ZONING CHANGE REVIEW SHEET

CASE: C14-2015-0073

ADDRESS: 7200 E. Ben White Blvd

ZONING FROM: GR-MU-NP & LI-NP **TO:** SF-6-NP

ZONING - EXHIBIT A

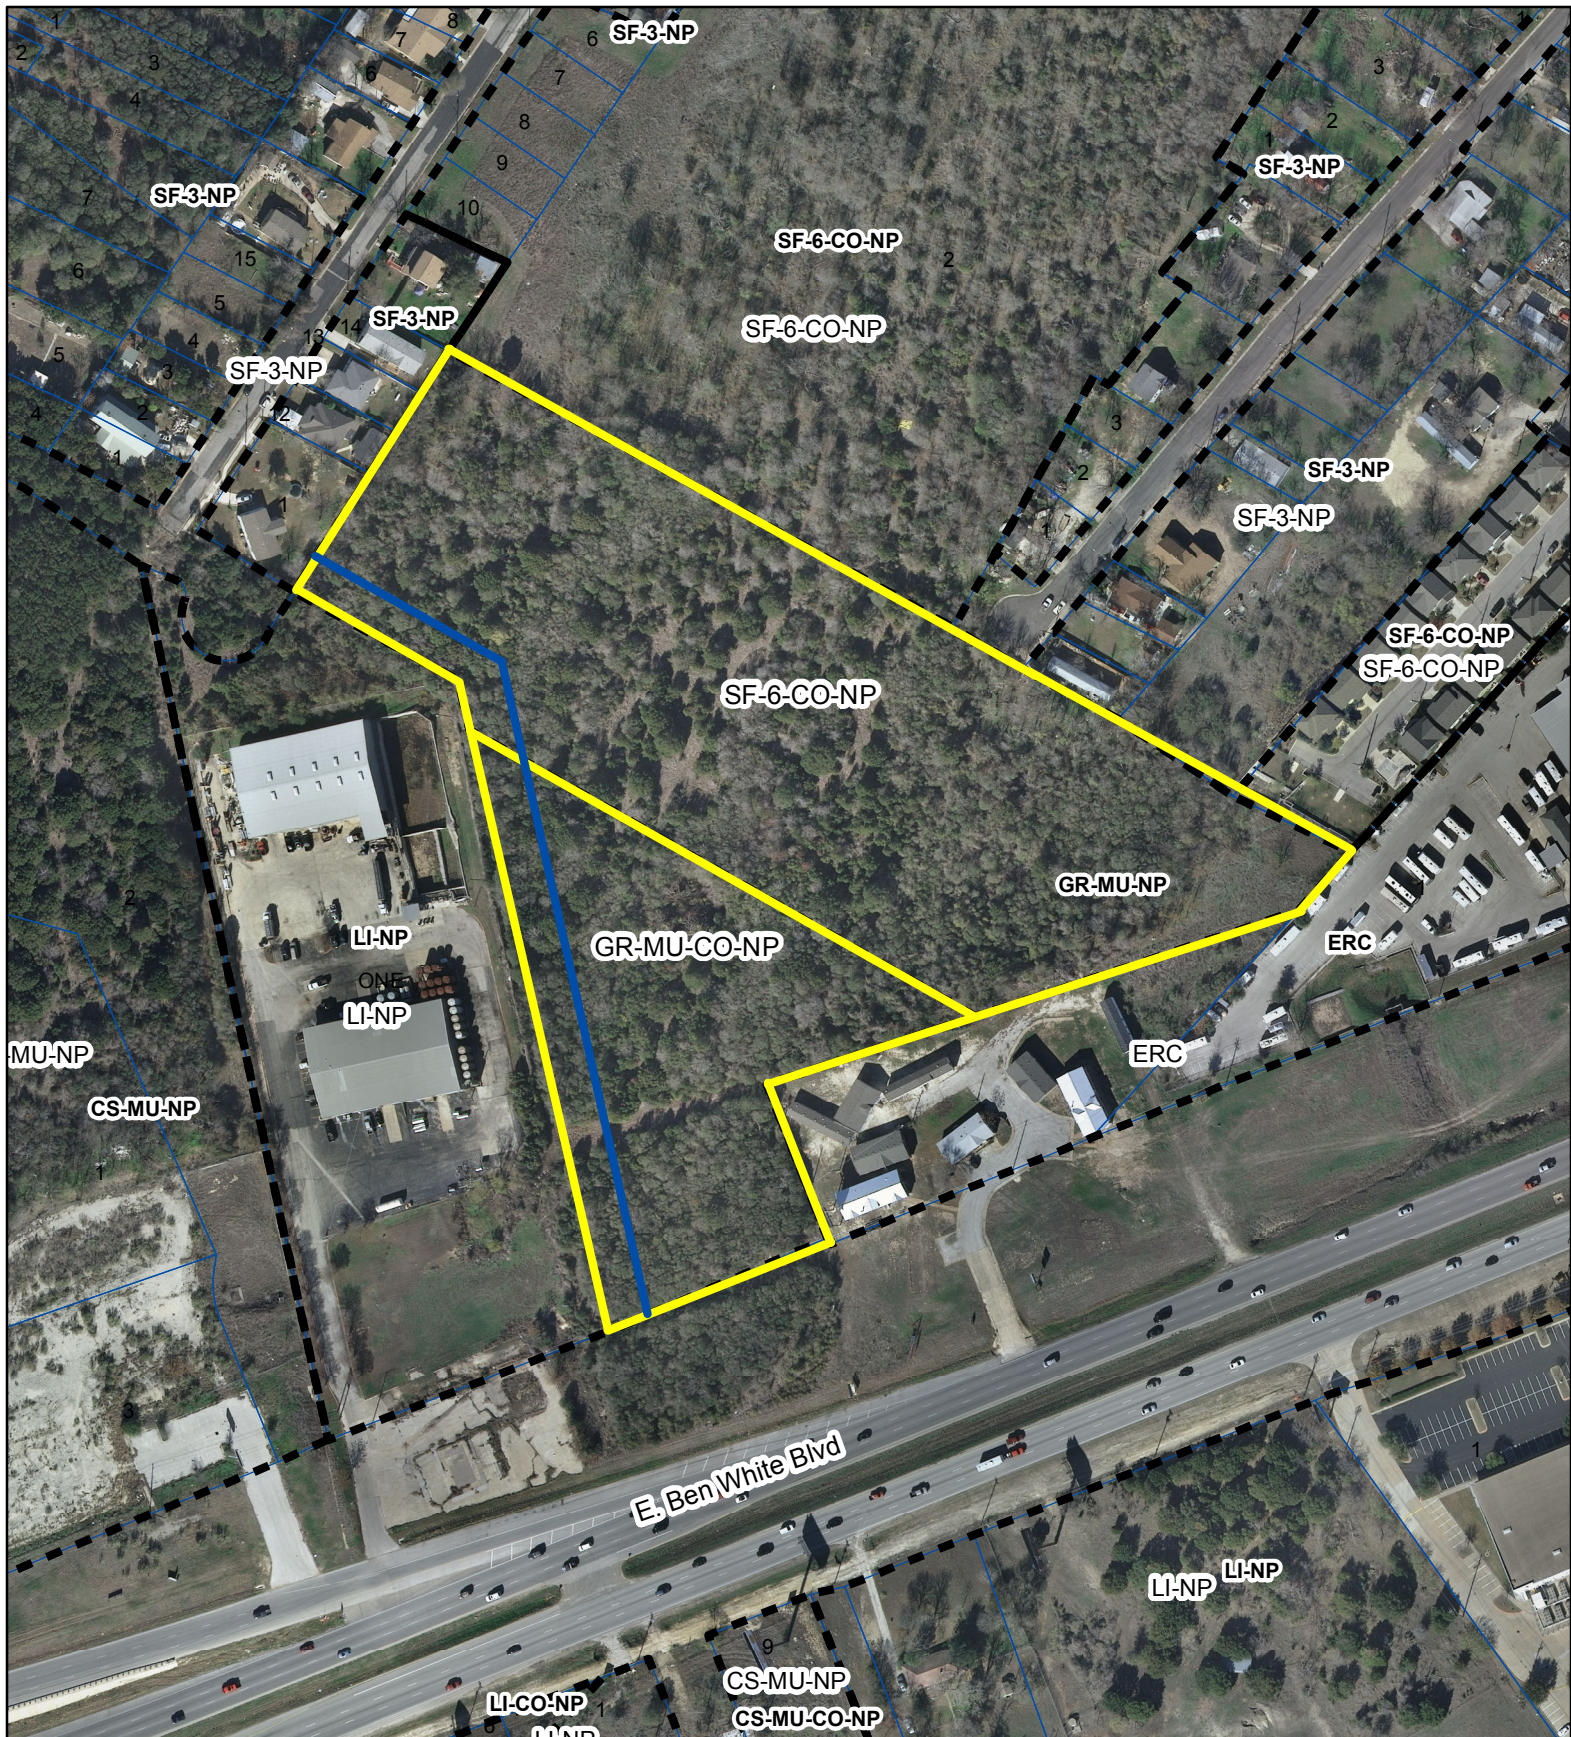
Recommend GR-MU-CO-NP & SF-6-CO-NP (Exhibit A)

The existing LI-NP would change to GR-MU-CO-NP and the existing GR-MU-NP would change to SF-6-CO-NP.

- If there will be a residential use, a 50 foot buffer is required along the boundary with LI-NP zoning (Exhibit A).

Figure 1-5: East Riverside Corridor Collector Street Map
Shows existing and new streets designated as Collector streets.

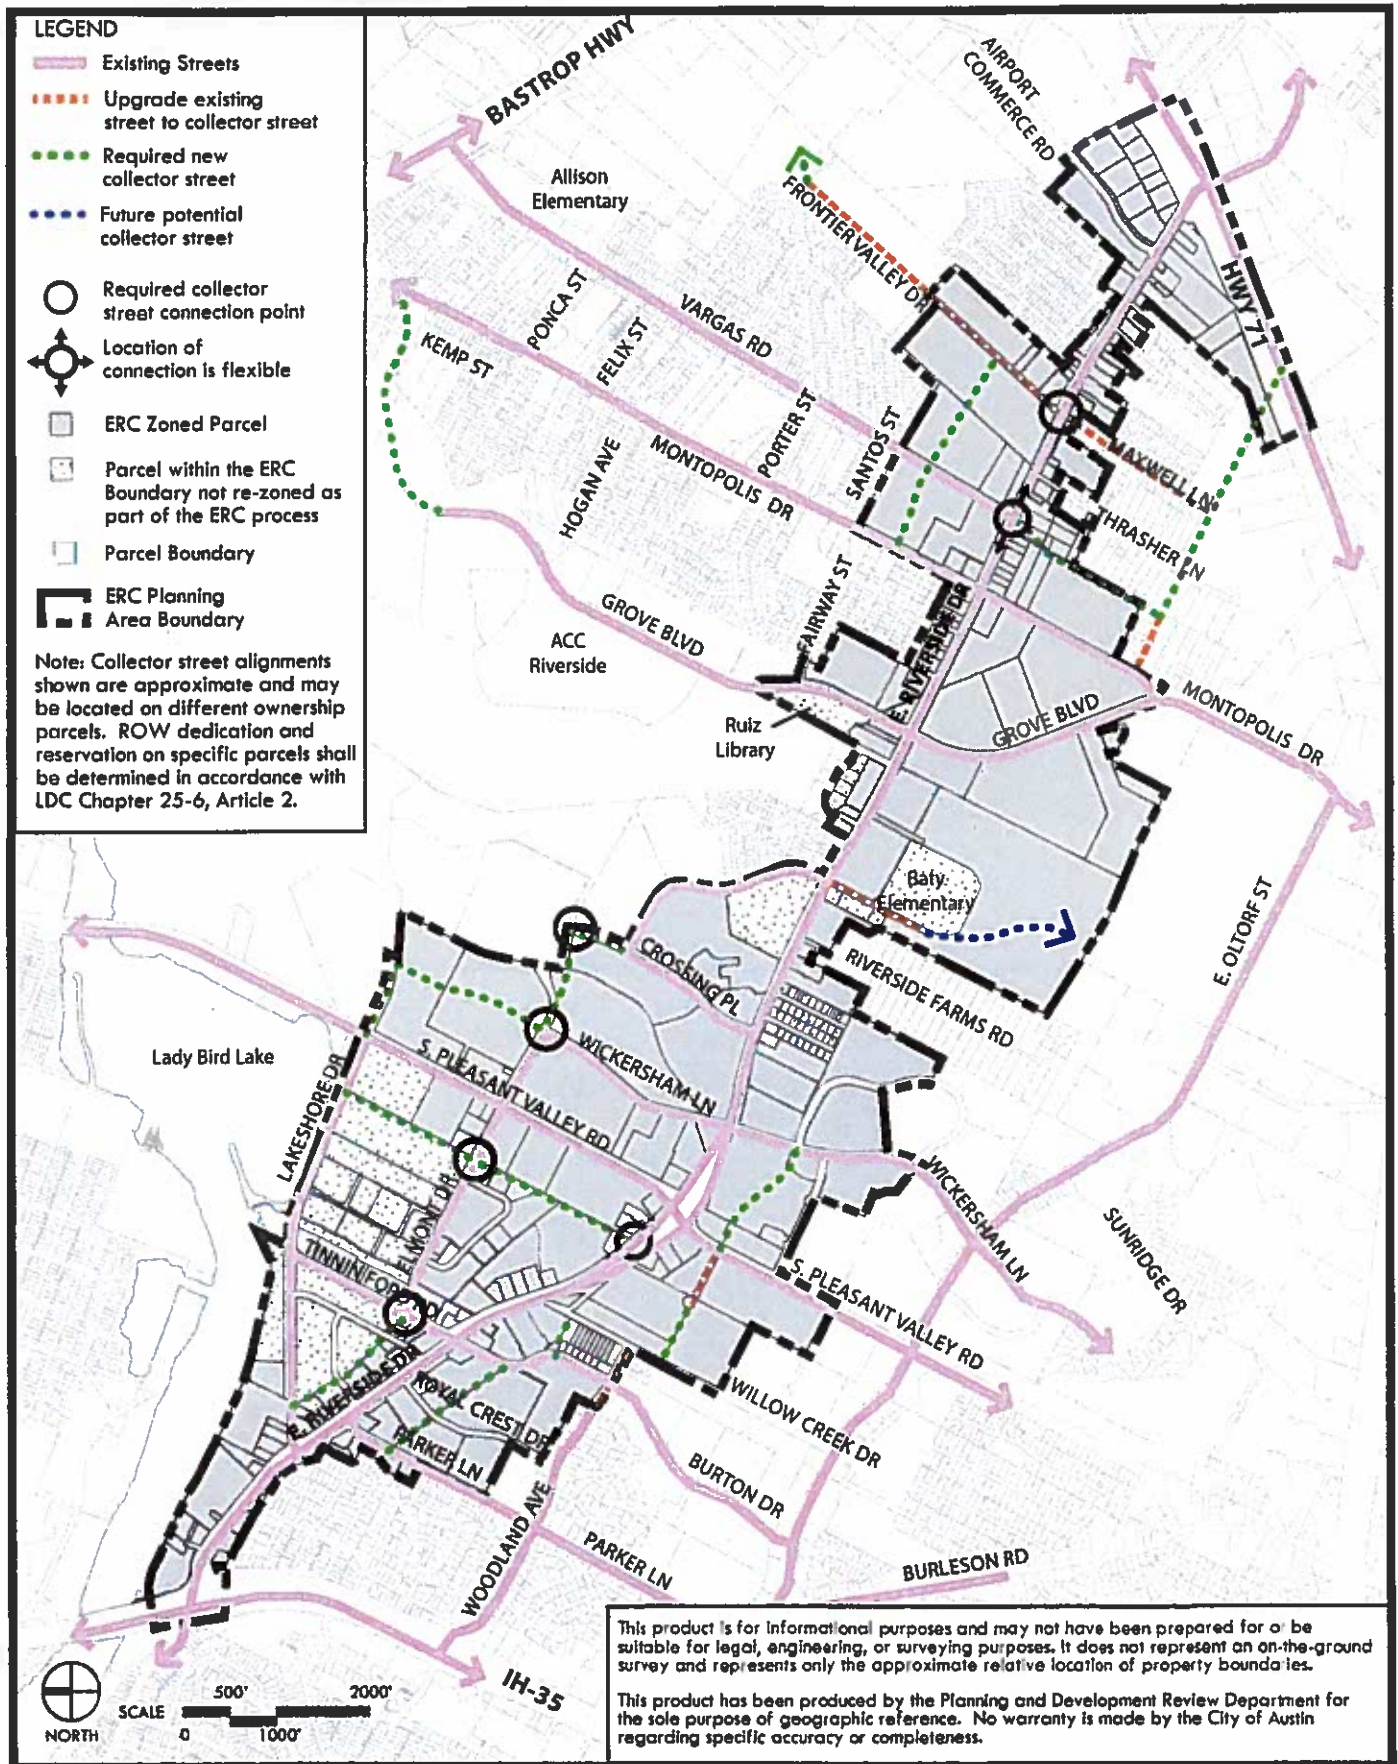
The East Riverside Corridor Plan shows the connection of Carson Ridge through this property to Ben White Blvd (Exhibit B1&B2). In addition, the Transportation department has recommended the extension of Yellow Jacket Lane through the property east to west. After discussions with Transportation and the applicant, it has been determined that the staff recommended buffer along the LI-NP property can serve as the right-of-way for the extension of Carson Ridge and provide access to Ben White Blvd. When the adjacent LI-NP property to the west is redeveloped, the remaining right-of-way should be dedicated for Carson Ridge. However, because of rough proportionality, the extension of Yellow Jacket Lane is not feasible in addition to Carson Ridge and access to Ben White Blvd. The priority was determined to be Carson Ridge and Ben White access which provide the added connectivity making the extension of Yellow Jacket unnecessary.

The East Riverside Corridor Plan requires the extension of Carson Ridge from Montopolis to Ben White Boulevard through this property. Right of Way should be dedicated to complete Carson Ridge.
